PROJECT : INSPIRE BKC

Inspection Report Prepared by:
Pankaj Ghare (Landscape Wall Systems) 9819663630

INSPECTION -1

INSPECTION -2

LEFT ELEVATION

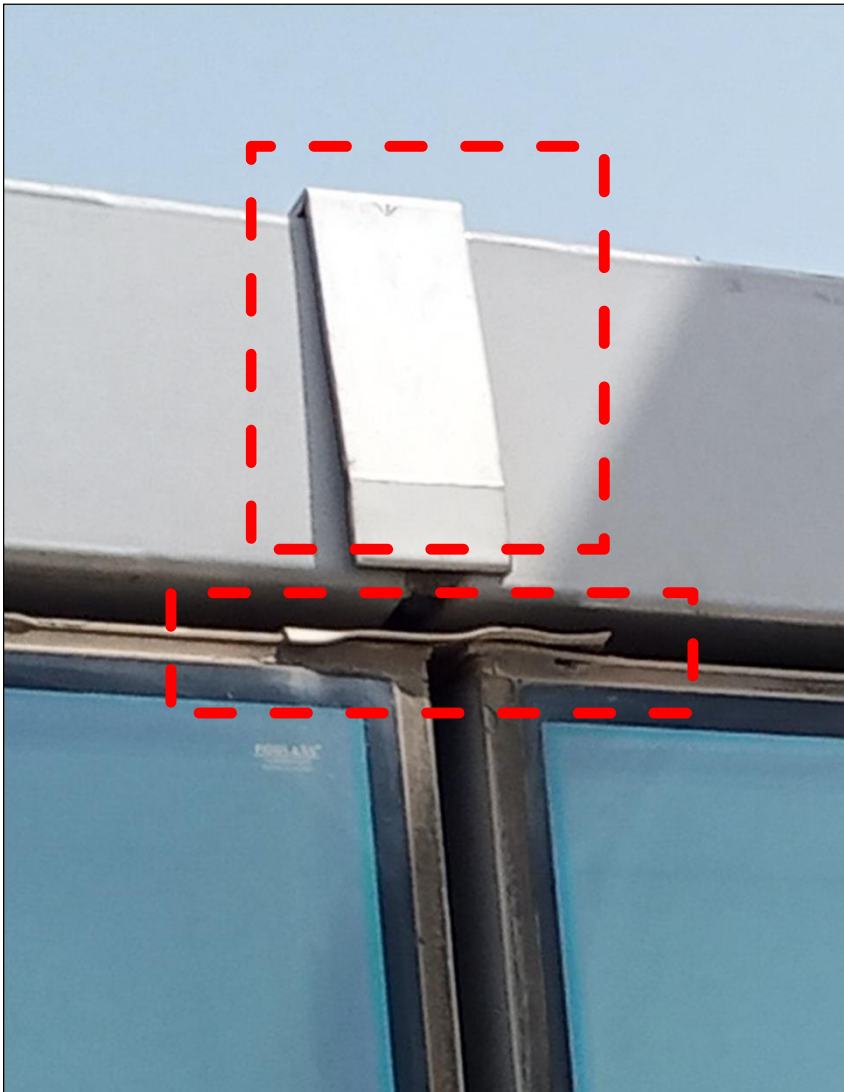
- Insufficient Silicone Filling at Side of ACP Strips
- Insufficient packing at top of Mullion

- Remove existing old silicone and replace with Fresh Silicone
- Fill the Gap at sides of Covering plate by Backer Rod and apply silicone at sides

LEFT ELEVATION

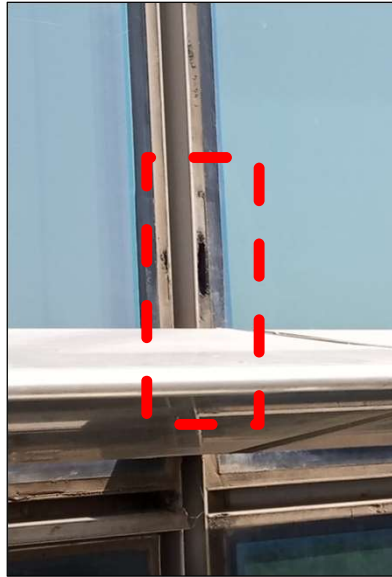
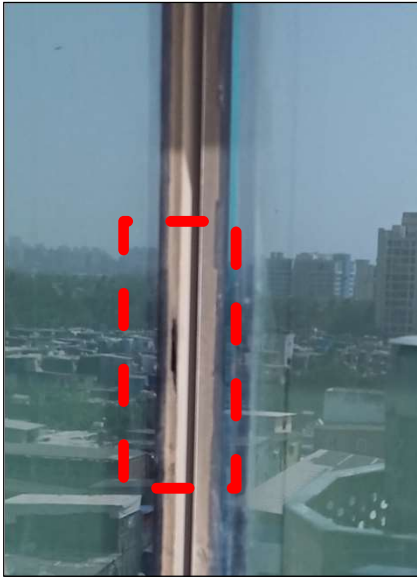
- Absence of Silicone at Side of ACP Strips
- Insufficient packing at top of Mullion

- Apply with Fresh Silicone at sides of ACP strips.
- Fill the Gap at sides of Covering plate by Backer Rod and apply silicone at sides

Location: Various Locations

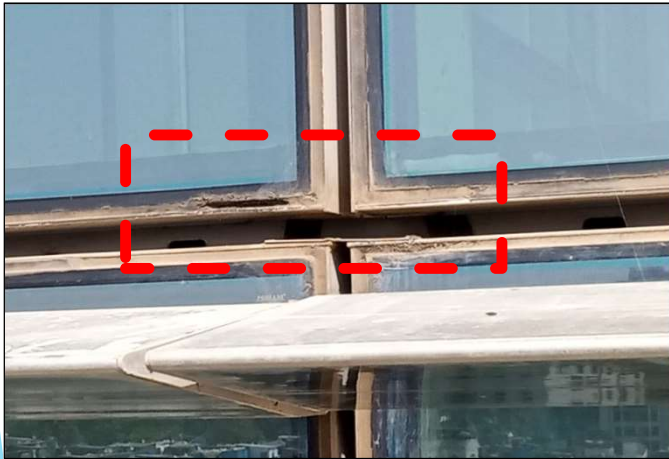
Silicone Removed (by Birds)

Location: Various Locations

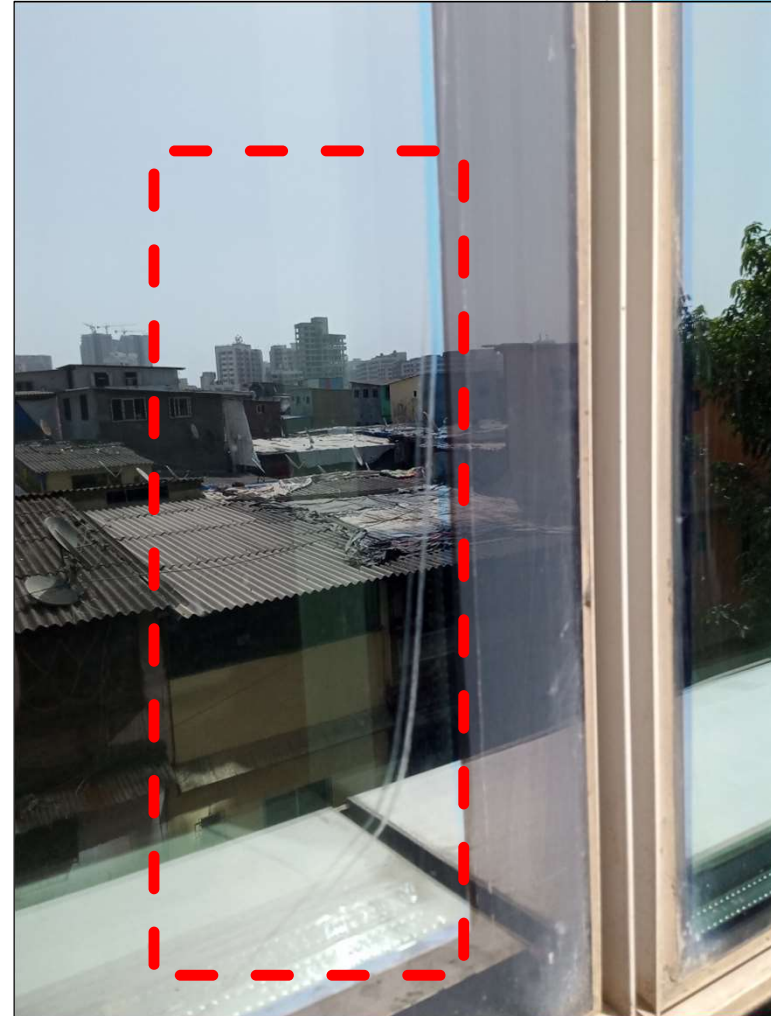
Screws used for Fixing the toggles to be removed and Fresh Silicone to be applied

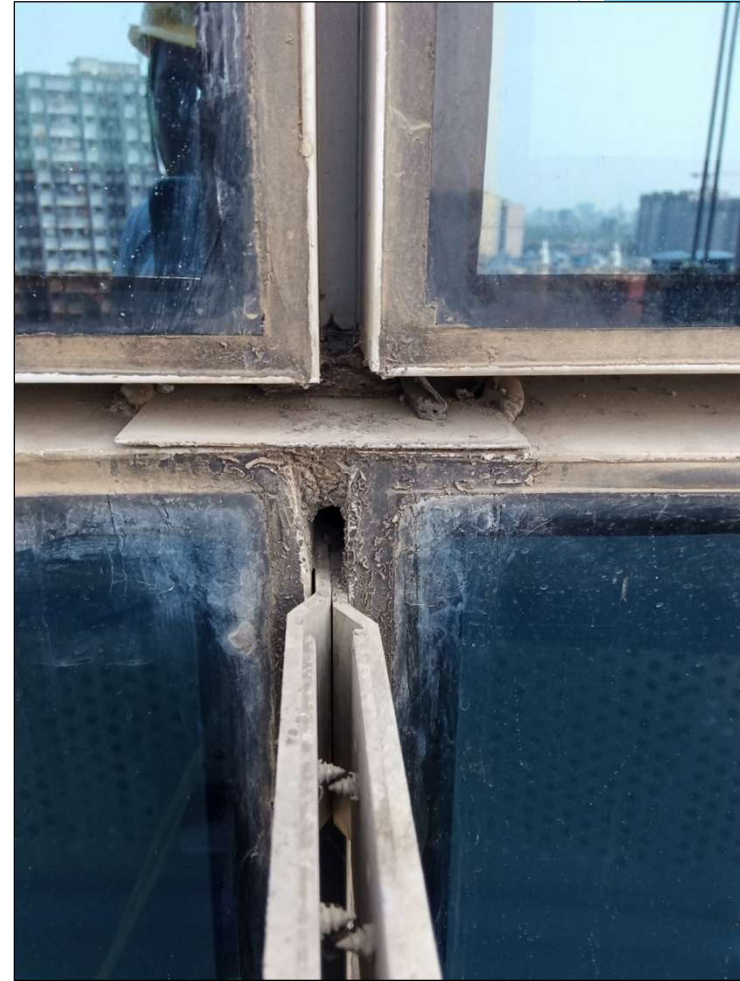
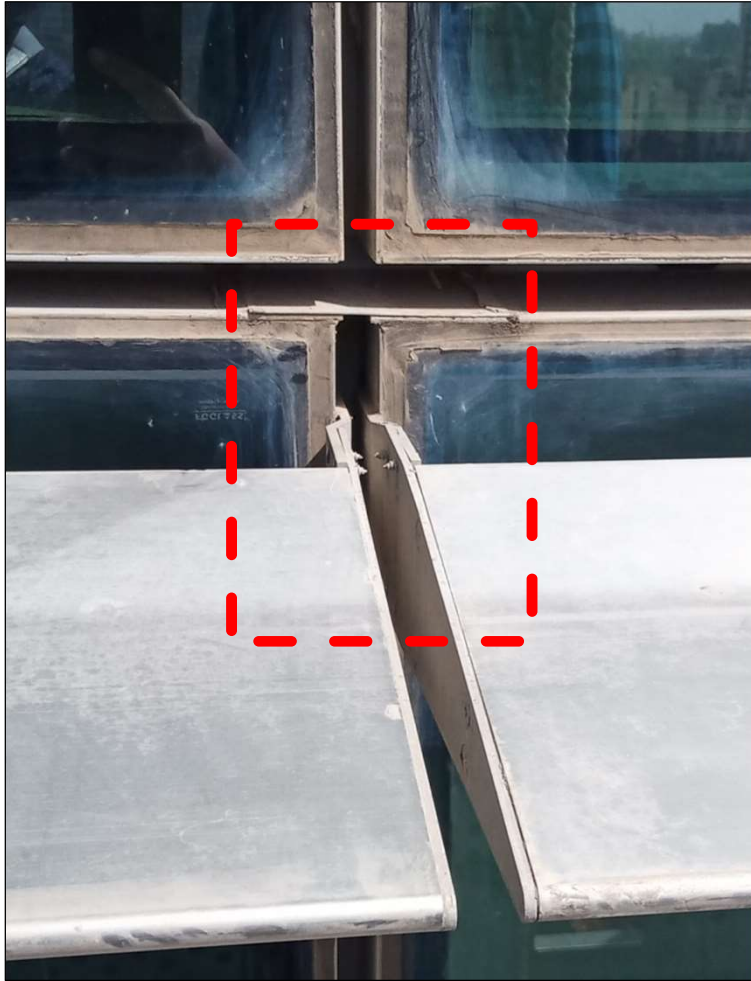
Scratches (Hairline Cracks) on Glass
Floor :3rd Floor ; Panel below Openable Window

Big Scratch on 2nd Floor ; Panel below Openable Window

Broken Toughened Glass at second floor

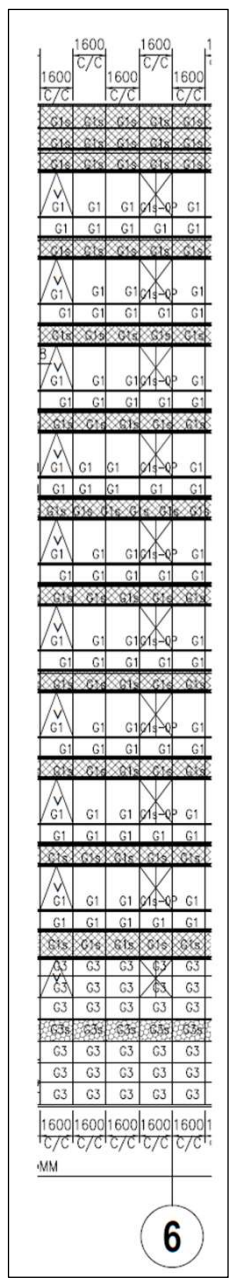
Dirty Spot on Glass from Inside

Floor :3rd Floor ; Panel to be checked from Inside

- Broken Glass at second floor is not replaced after shifting the cradle at this location. (only at 5th floor, broken glass is replaced.
- This happens because of Impurity (Nickel Sulphide Inclusion) in Glasses.
- This can be avoided by Heat Soaking Process on Glasses during Fabrication.
- It costs higher than Non Heat Soaked glass and for Smaller Quantity Processors do not take order for Heat Soaking .

Location: 3rd Floor ; Panel besides Openable Panel

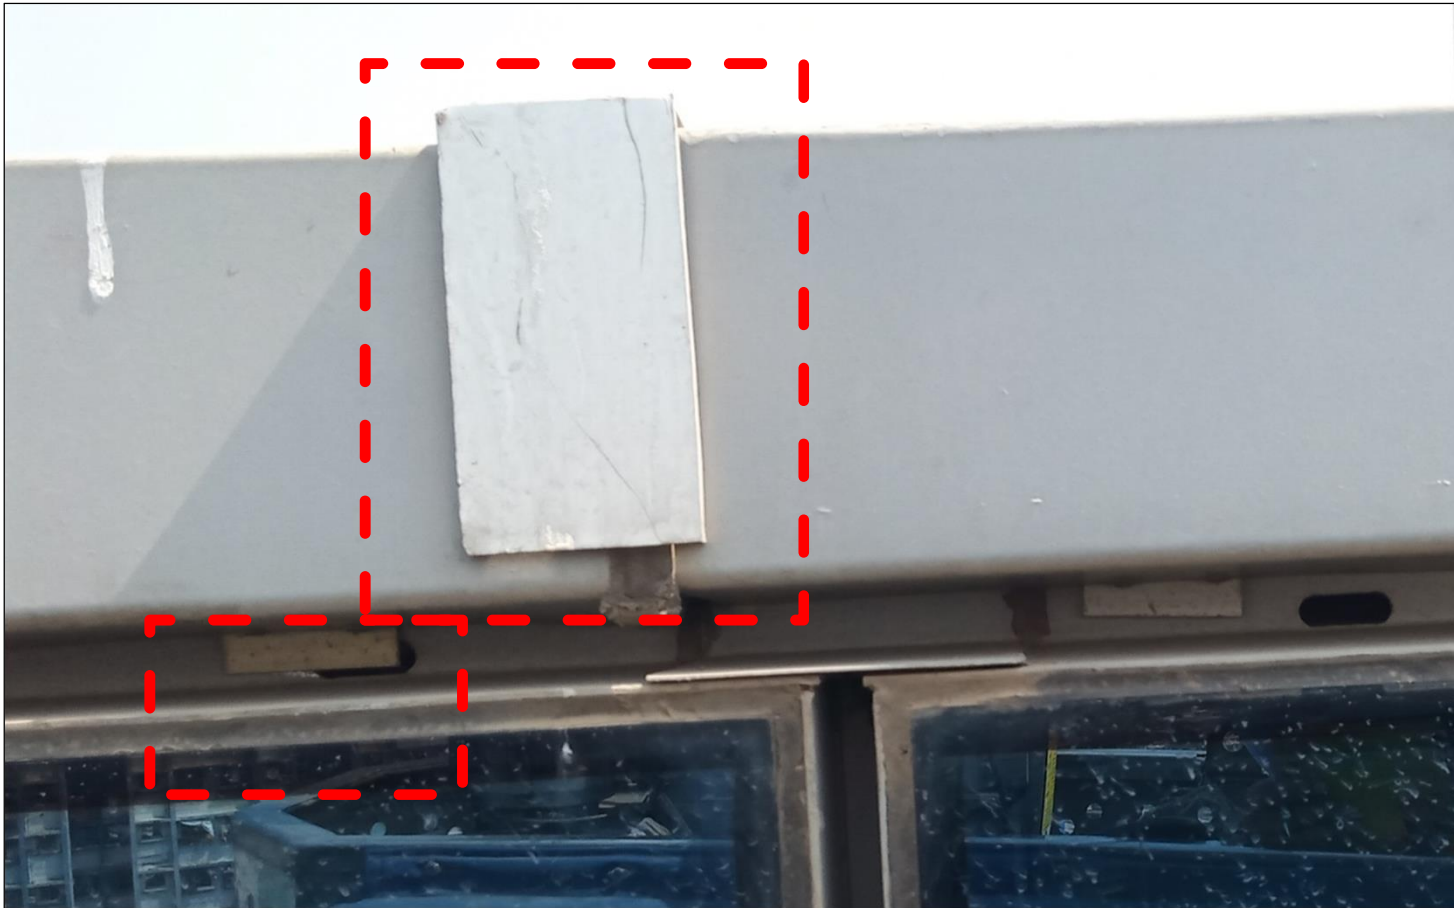
Observation: Water accumulation at the Openable Window to be checked from Inside

- Length of Flashing Protruding outside seems less.
- If required additional flashing maybe required

Location : Terrace Level

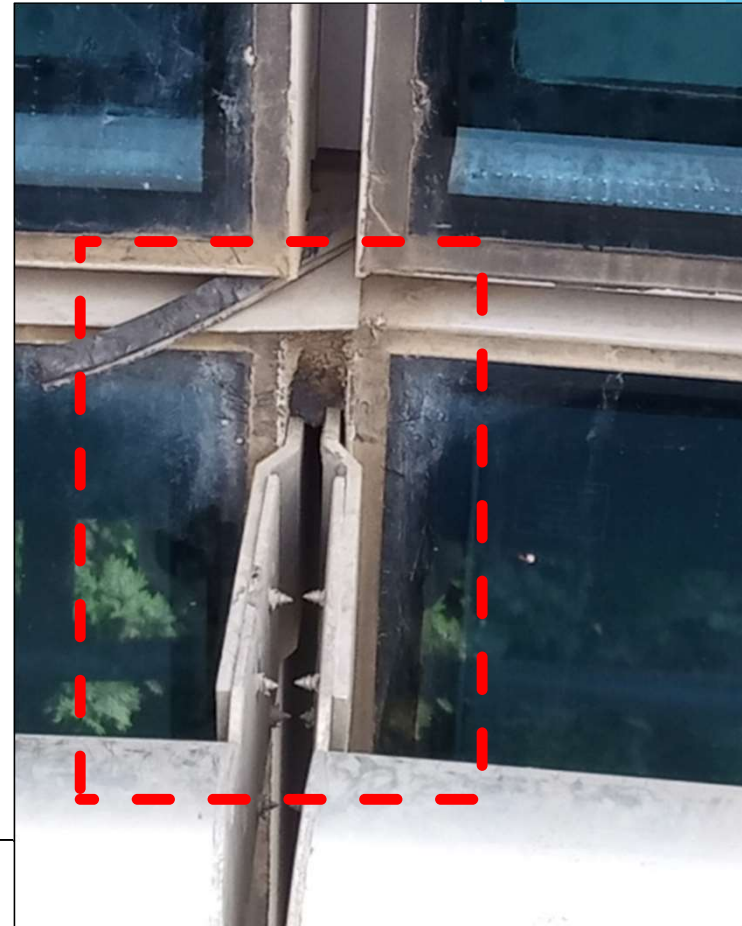
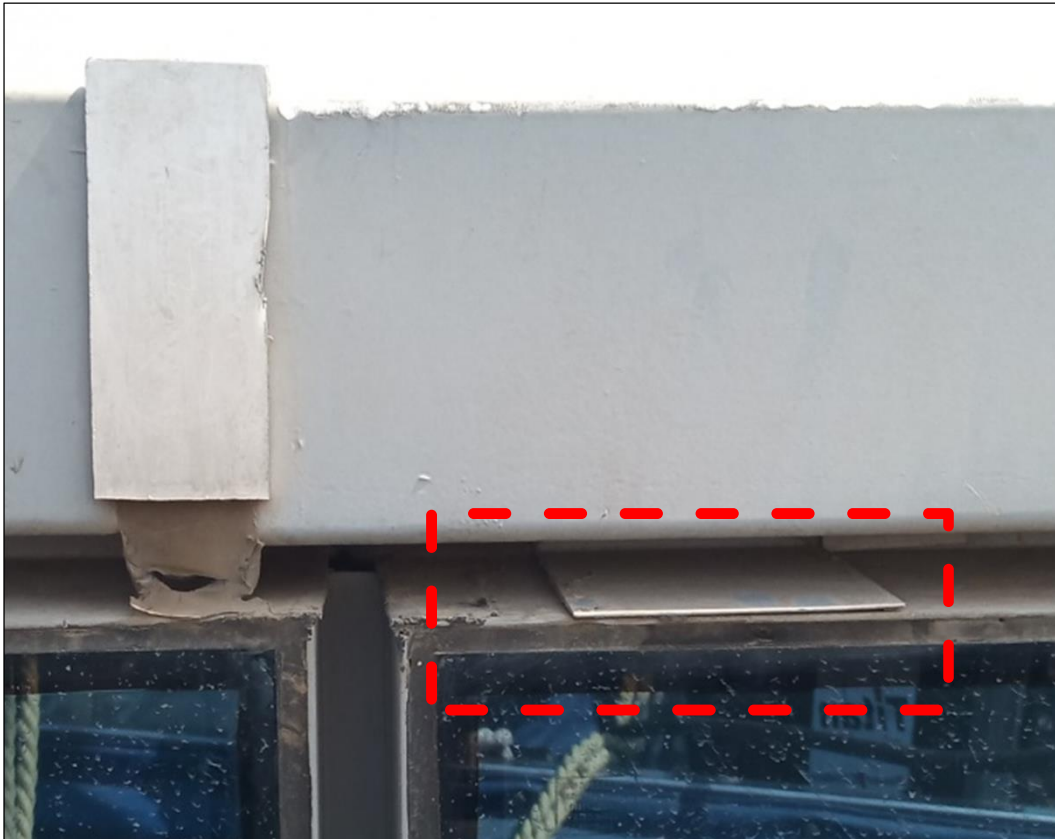
Observation : Weep Hole is obstructed by 1mm Thk. Aluminium Sheet. Silicone missing at the sides of ACP strip.

Location : Terrace Level

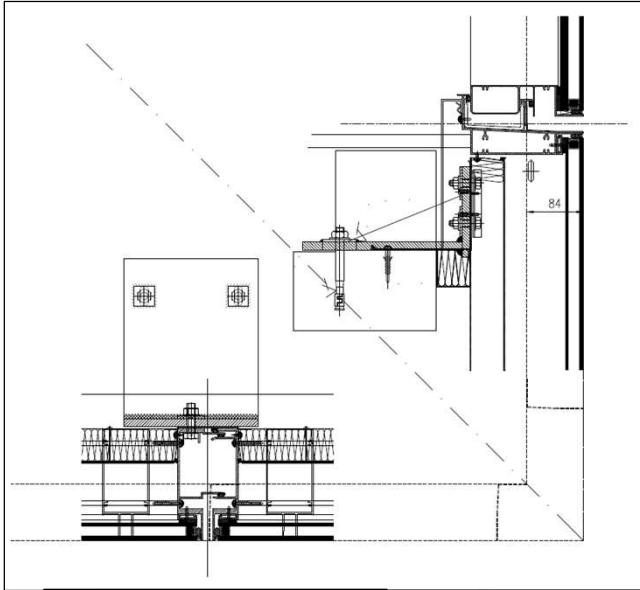
Observation: Dislodge 1mm Thk. Aluminium sheet. Should be placed as like in another image.

Solution: Silicone with Baker Rod to be placed at every location where such Alum sheet is placed for confirmation of proper closure at mullion

PLAN DETAIL

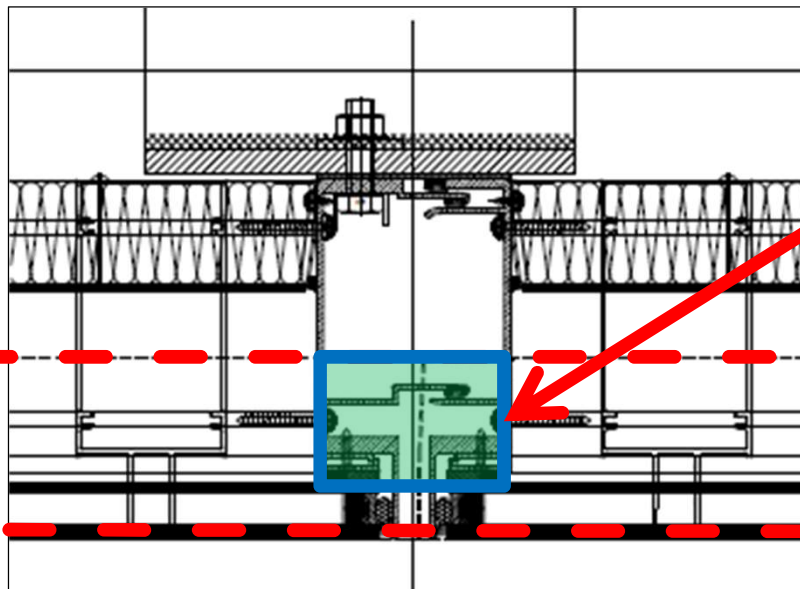
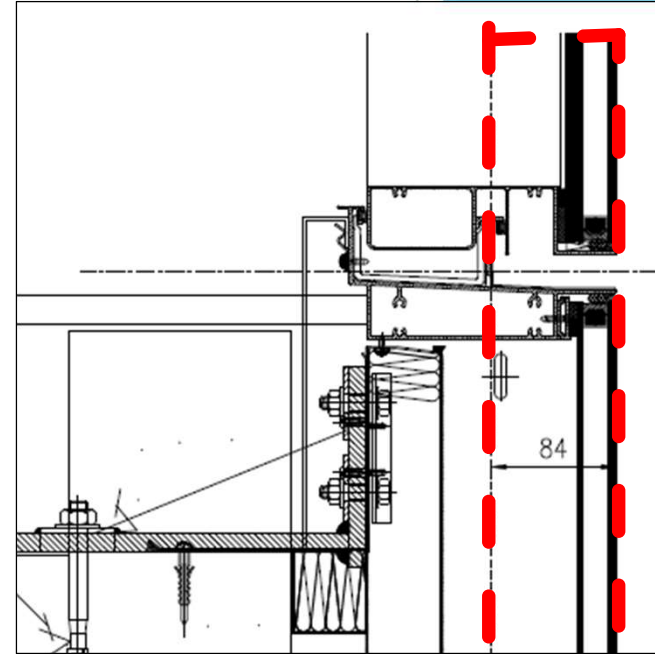
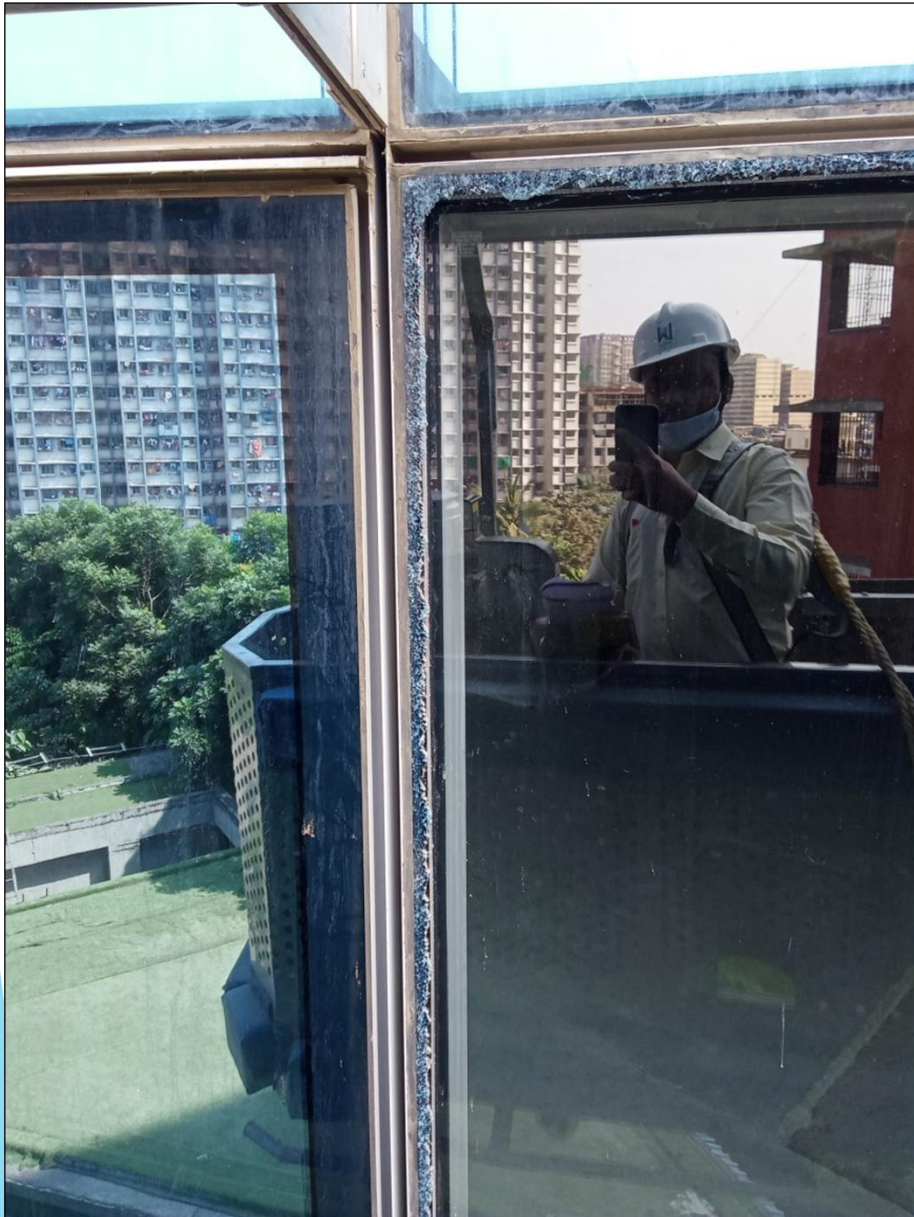
**AREA
COVERED BY
GI SHEET
(IN PLAN)**

**AREA AFFECTED
DUE TO
DISLODGE-
MENT
OF GI SHEET**
